**Planning Application for
Minor Relaxation of Building Height Restriction to Construct a Car Park and an
Ancillary Plant Room at Basement Level for Permitted Residential Development
at No. 3 Lincoln Road,
Kowloon Tong, Kowloon
(New Kowloon Inland Lot No. 713)
(Planning Application No. A/K18/350)**

We submit herewith a set of replacement pages of the Application Form and "Response-to-Comments" in responding to the government departmental comment for the captioned planning application.

Response-to-Comments

Indication Plan A

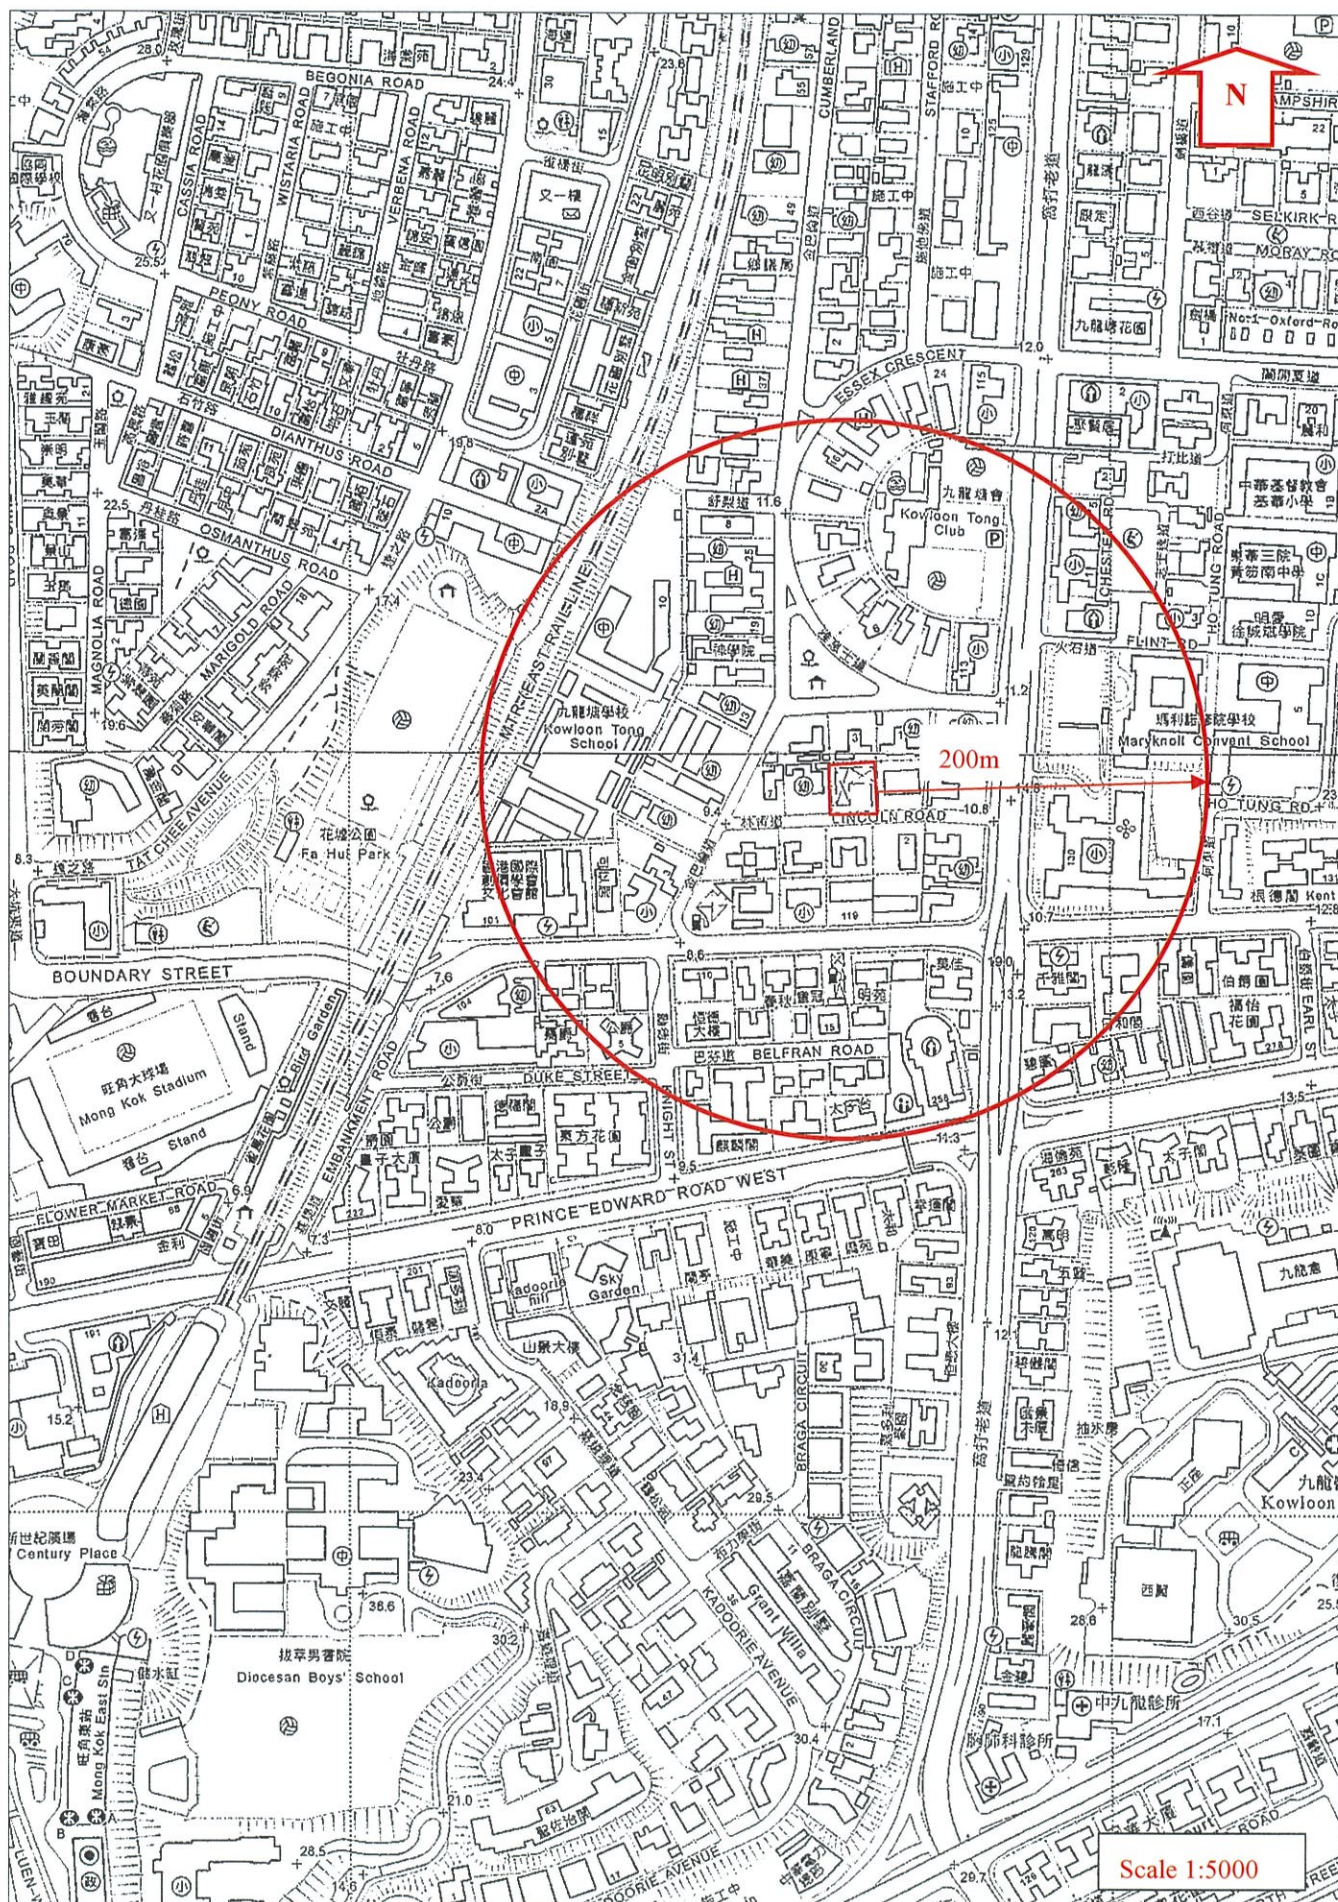
(a)	On <u>air quality</u> , the applicant should provide clarification of the following for our further consideration.	
(i)	Please confirm whether the buffer distance requirements for vehicular and chimney emissions (e.g. any active industrial chimney within 200m) stipulated under the Hong Kong Planning Standards and	<p>Please note the followings:</p> <ul style="list-style-type: none"> - there is no active industrial chimney within 200m from the site, as shown in the Indication Plan A at Appendix 4; and
